*Technical Service
Information Bulletin
November 14, 2011*

**Subject:
2050-1 and 2050-1A
ramp and U-bracket
replacement**

TSIB number 138

First design —

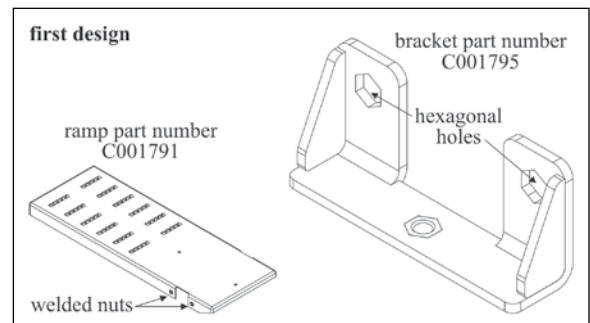
- “Does the ramp have nuts welded in it and does the ramp mounting U-bracket have hexagonal holes?”
“Is the overall length of the ramp 45-5/8 inches?”
If “yes,” —
replace with ramp part number C001791 and U-bracket C001795.

Second design —

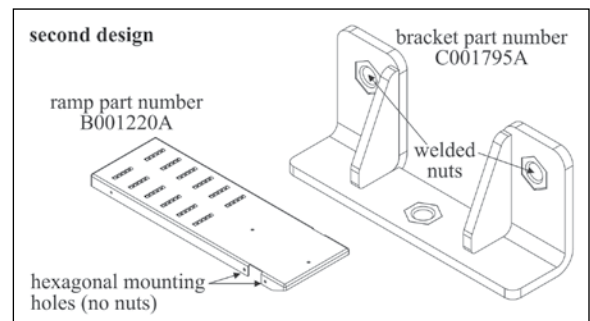
- “Does the ramp have hexagonal mounting holes for the ramp mounting U-bracket (no nuts)?”
“Does the U-bracket have welded nuts?”
“Is the overall length of the ramp 47-5/8 inches?”
If “yes,” —
replace with ramp part number B001220A and U-bracket C001795A.

Current design —

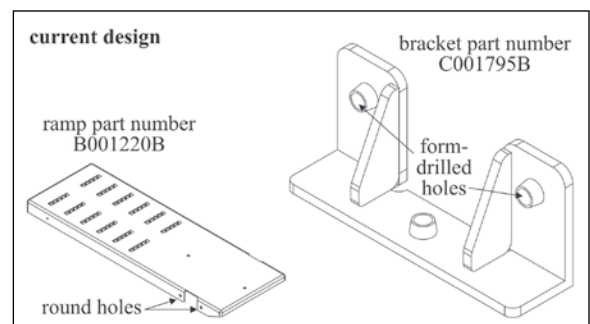
- “Are the last five digits in the serial number 89212 or greater?”
If “yes,” —
replace with ramp part number B001220B and U-bracket C001795B.
If the serial number cannot be read — the current design ramp has round bracket mounting holes; the U-bracket has form-drilled holes (the threads are formed into the metal).

- If the customer is replacing **both** ramps and U-brackets —
Regardless of what version the customer has, the current design will fit — order B001220B ramps and C001795B U-brackets.
